Re: Soil Vapor Investigation
Broadway, Schenectady Former MGP Site
Site No. 4-47-026

Re: Schenectady Broadway
Former MGP Site, Site No. 4-47-026
Schermerhorn Creek Isolation

This letter responds to comments the City provided to National Grid in a letter dated September 11, 2009 regarding the isolation of Schermerhorn Creek. For ease of review, each comment presented in the September 11, 2009 letter is provided below followed by a response.

Subject:
National Grid
Schenectady (Broadway) Former MGP Site
Response to NYSDEC Comments to Soil Vapor Sampling

Figure 1
Schermerhorn Creek Hydrograph
at National Grid Site

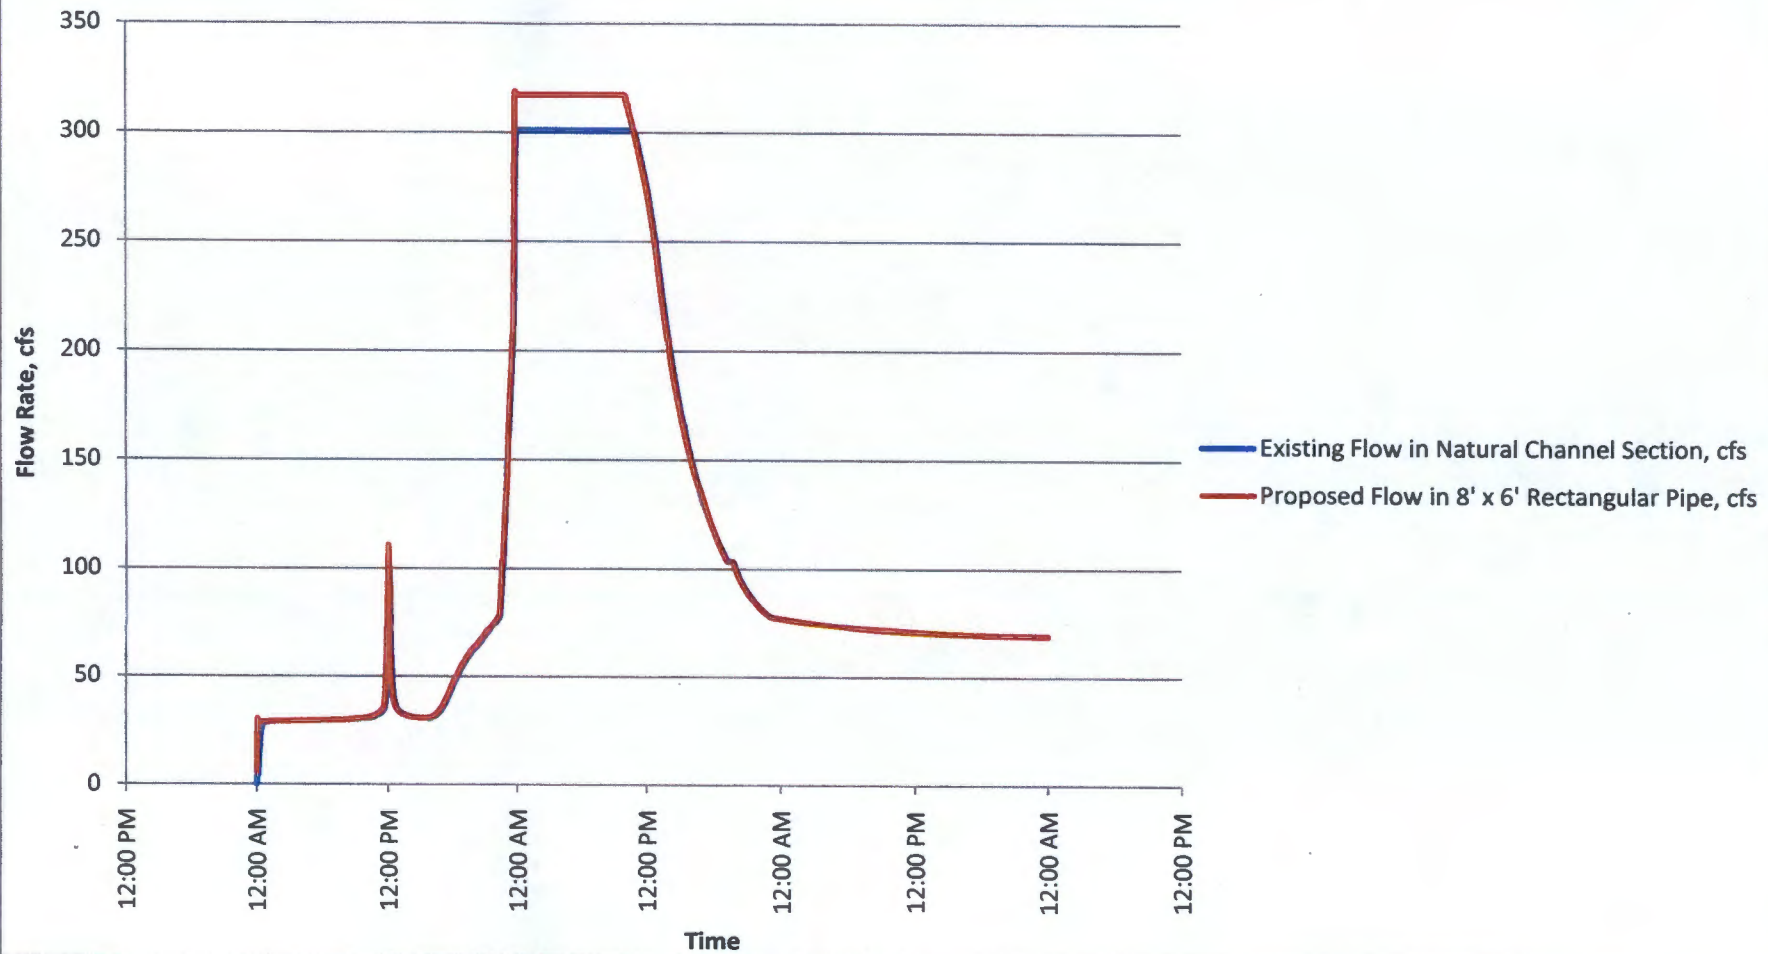
We understand National Grid's position that work beyond the site limits is not their responsibility, however, this statement is only valid if their proposed box culvert construction does not have adverse impact on downstream properties, including Weaver Street.

Contact with the Schenectady County Engineering Department was made regarding the redevelopment at 797 Broadway. The hydraulic model of Schermerhorn Creek has been revised to include the estimated flows from the storm sewers entering the creek from Broadway. The sizes of these culverts were taken from the drawings and information provided by the City and County Engineering Departments. Though the slope of these pipes is unknown, estimates have been made of the amount of stormwater they contribute to Schermerhorn Creek using an assumed pipe slope to estimate the hydraulic capacity of each. These hydraulic capacities were input into the existing and proposed versions of the model as a constant flow. The addition of these constant flow rates is reflected in the additional modeling described below in item 2.

Figure 2
Schermerhorn Creek Water Surface Elevation
at Upstream End of Weaver Street Culvert

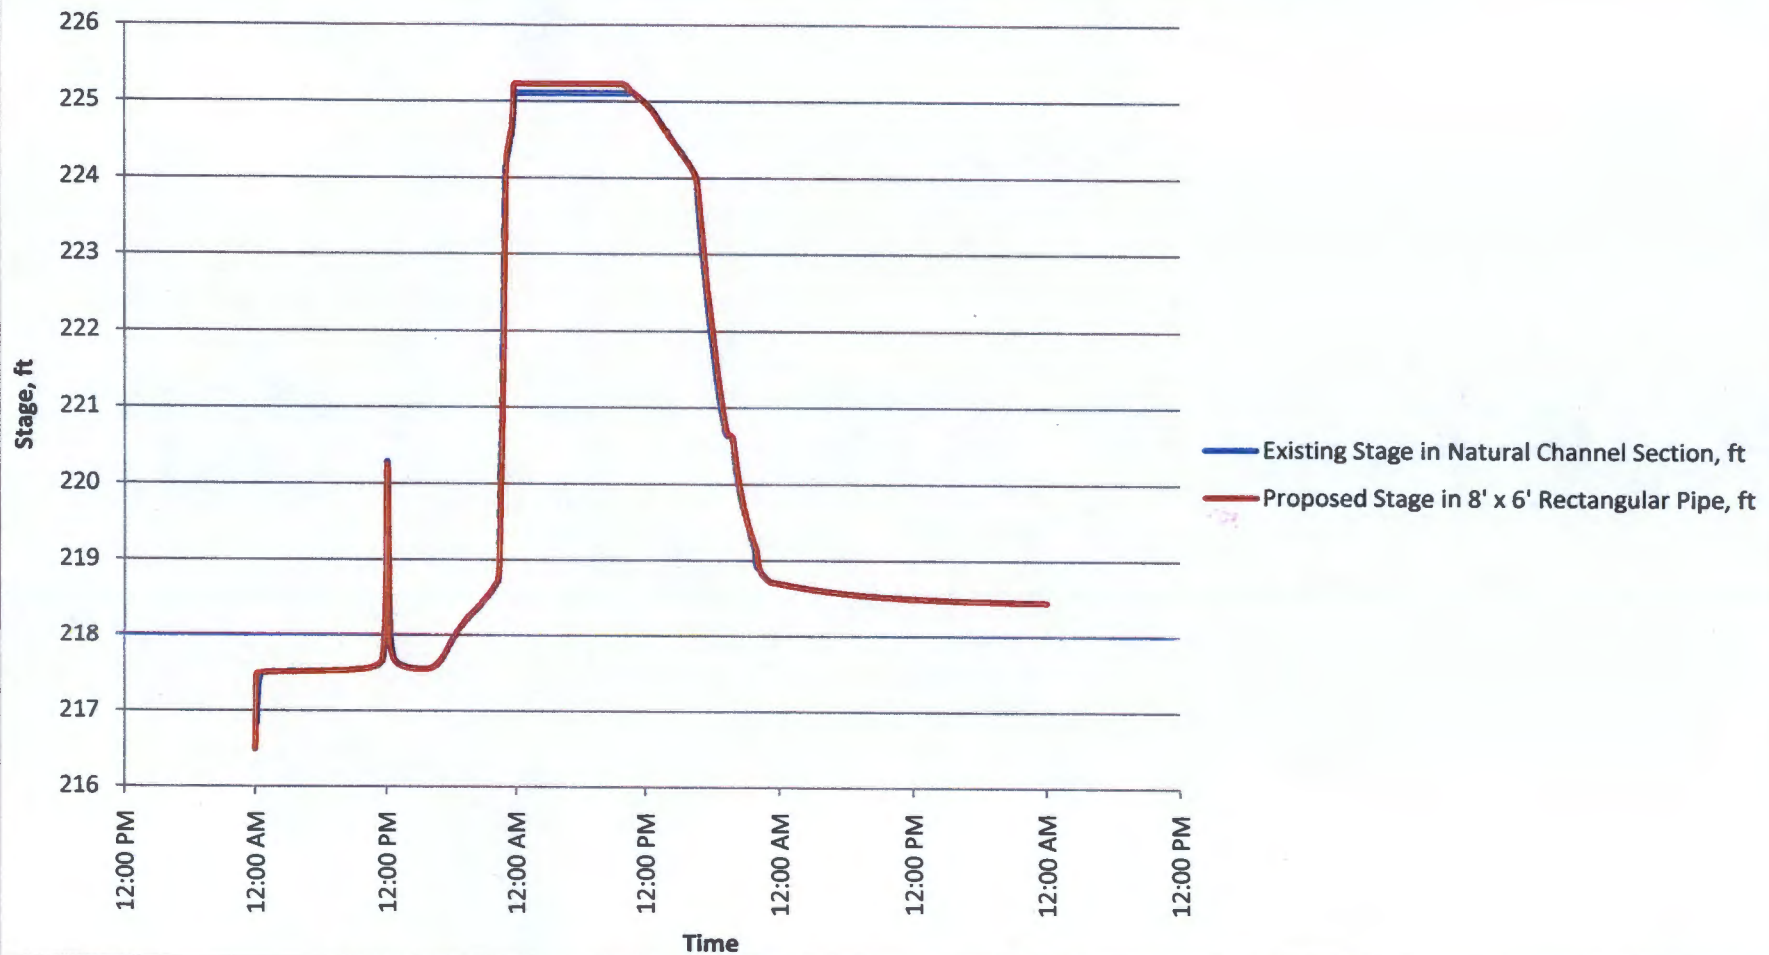
We have reviewed the hydraulic model results provided in Attachment A. We question how the HGL elevation for higher intensity storm events show a decrease in elevation, i.e. 10-year storm @ el. 225.18 versus 25-year storm @ el. 225.17. The table also shows the 25-year storm volume of flooding across Weaver Street (ft³) to substantially increase for proposed conditions with an additional 717,672 ft³, equal to approximately 16.5 acre-feet. Where will this additional flood volume go and how will it be accommodated? We also question the accuracy of the calculations for flooding under 25-year existing conditions showing a flood volume of approximately 620 acre-feet?

Response: The difference in peak hydraulic grade line elevation at the upstream end of the Weaver Street culvert between the 10-year and 25-year storms is caused by a slight difference (1 cfs) in peak flow rate through the proposed 8-ft x 6-ft rectangular pipe. This difference is caused by model calculation rounding and small time-of-travel differences caused by the small changes in peak flow rates. For each of the design storms presented in Attachment A of our August 17, 2009 letter, the peak flow rate leaving Fuller Pond through the outlet structure was 695 cfs. Similarly, the peak flow rate in the existing 3.5-ft x 7.0-ft rectangular pipe was 292 cfs for each design storm.

It is our understanding that the City does not want increased flooding across Weaver Street. In an effort to best match the existing flow condition, two variations of the proposed design were simulated. These variations included smaller proposed rectangular culvert pipe sections (a 7-ft x 6-ft and a 6-ft x 6-ft section – the next two smaller standard size rectangular pipe sections). The results of these additional modeling efforts are summarized in Attachment A. When compared to the originally proposed 8-ft x 6-ft rectangular culvert pipe, the two variations both reduce the total volume that flows across Weaver Street (through the culvert and flow across the roadway), reduce the peak flow rate through the site, and reduce the hydraulic grade line elevation at the upstream end of Weaver Street. Although the results do not match the existing condition (i.e., flooding both upstream and downstream of the site) exactly, they are the best fit in replicating the current condition. Figure 1 illustrates the hydrographs through the natural channel section and the originally proposed 8-ft x 6-ft rectangular pipe. Figure 2 illustrates the hydraulic grade line at the upstream end of the Weaver Street culvert for the natural channel section and the originally proposed 8-ft x 6-ft rectangular pipe.

Based on the hydraulic modeling described above, the exact replication of the existing conditions is not possible using a rectangular pipe. Under current conditions, during the design storm, flooding occurs both upstream of the site on Broadway and across Weaver Street. Attachment B demonstrates the effect of installation of various size culverts on the flooding at the upstream catch basin and across Weaver Street. As shown on Attachment B, installation of a 7-ft x 6-ft rectangular culvert pipe to convey Schermerhorn Creek across the National Grid Property will result in flow conditions most similar to those that currently exist during the design storm. Installation of a 7-ft x 6-ft rectangular culvert best replicates the existing condition resulting in a marginal decrease in total flooding at the upstream catch basin on Broadway by approximately 3% and a marginal increase in the total volume across Weaver Street by approximately 2%. This increased flow across Weaver Street will result in a calculated increased peak flow depth of 0.03 ft (0.36 inches). As such, National Grid will re-design the box culvert from the original design size of 8-ft x 6-ft to be 7-ft x 6-ft as this size will most closely mirror the existing flow conditions.
